DEVELOPMENT REVIEW BOARD REPORT

CASE NUMBER/ 62-DR-2005

Barolo Place Condominiums

REQUEST Request approval of a site plan and elevations for a 65-unit condominium/

4. Site Plan

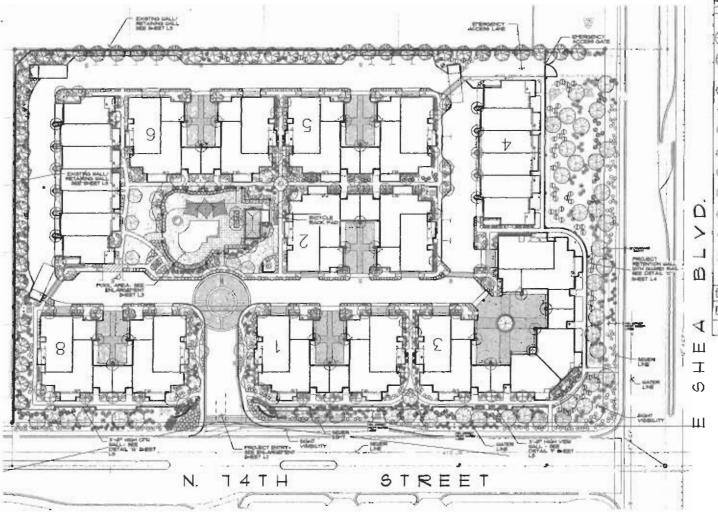
11. Revise site plan worksheet to graphically show private open space areas and private open space calculations, to the satisfaction of Final Plans staff.

- 22. The internal streets shall be private. Provide emergency access fire lanes as required by the City Fire Dept.
- 23. The developer shall design and construct one driveway on 74th street in general conformance with COS DSPM figure 5.3-40 CH-2.

- 31. The developer shall provide a minimum parking-aisle width of 24 feet, even at the knuckles where the DRB site plan shows the lane width to be 20 feet.
- 32. The developer shall provide internal circulation that accommodates emergency and service vehicles with an outside turning radius of 45 feet and inside turning radius of 25 feet.
- 33. Use City standard bike racks, or get approval from Transportation department for alternate style.
- 34. Modify geometry of drive at southeasterly "knuckle" (where the emergency access entrance is located) to provide better flow of vehicular traffic and better visibility. May need to relocate refuse at this location.

ATTACHMENT #5

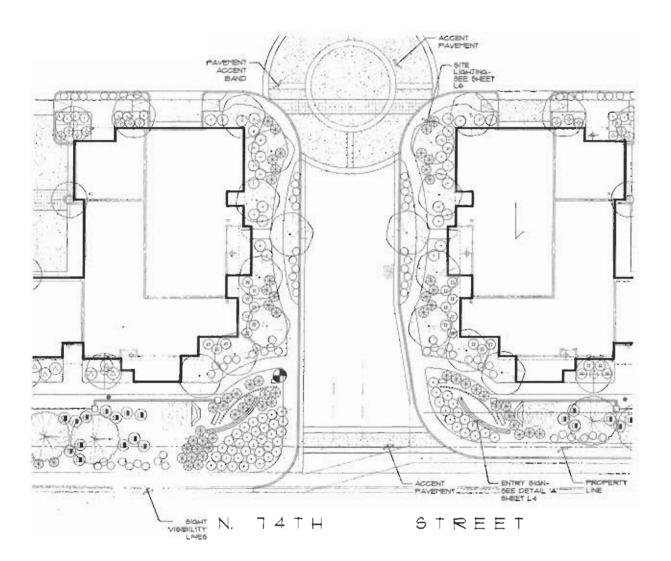
- G. All trees along the north & east property lines shall be mature to screen buildings from adjacent single-family neighborhoods, as per case #7-ZN-04.
- H. Revise landscape plan to show water-intensive (turf) calculations, to the satisfaction of Final Plans staff.
- Fifty percent of proposed trees shall be mature, as defined in Article III of the Zoning Ordinance. For
  each building story over one (1), all required mature trees shall increase in caliper by one-half inch for
  multi-trunk trees, and 1 inch for single-trunk trees.

ATTACHMENT #6

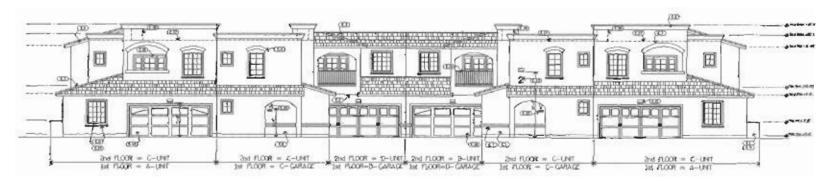
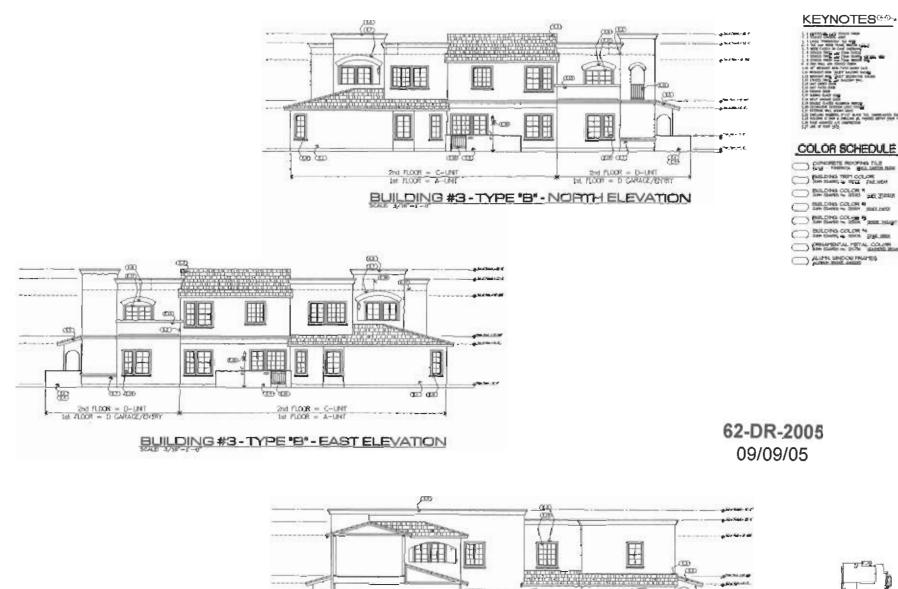
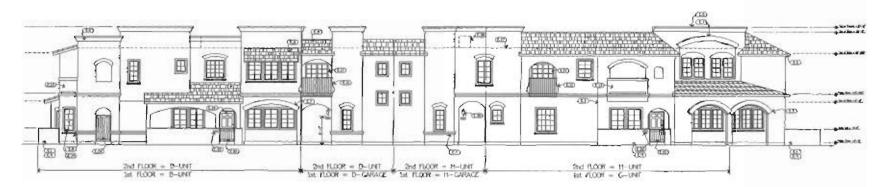
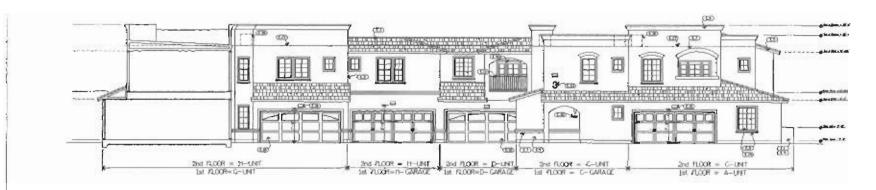
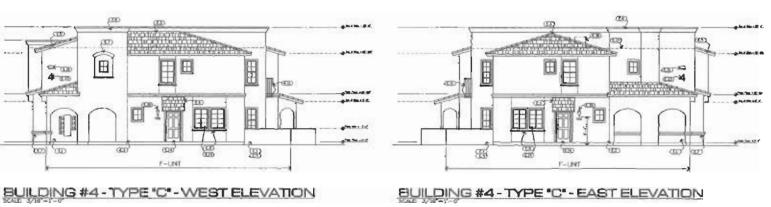
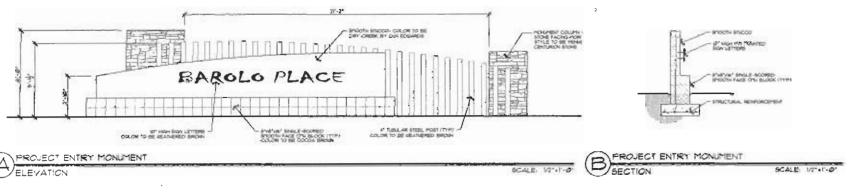
- 8. Dooley wall fencing shall not be allowed.
- 9. All walls shall match the architectural color, materials and finish of the building(s).
- 10. Windows shall be recessed to 50% of wall depth measured from the external face of glazing to the external face of wall, excluding external detailing.
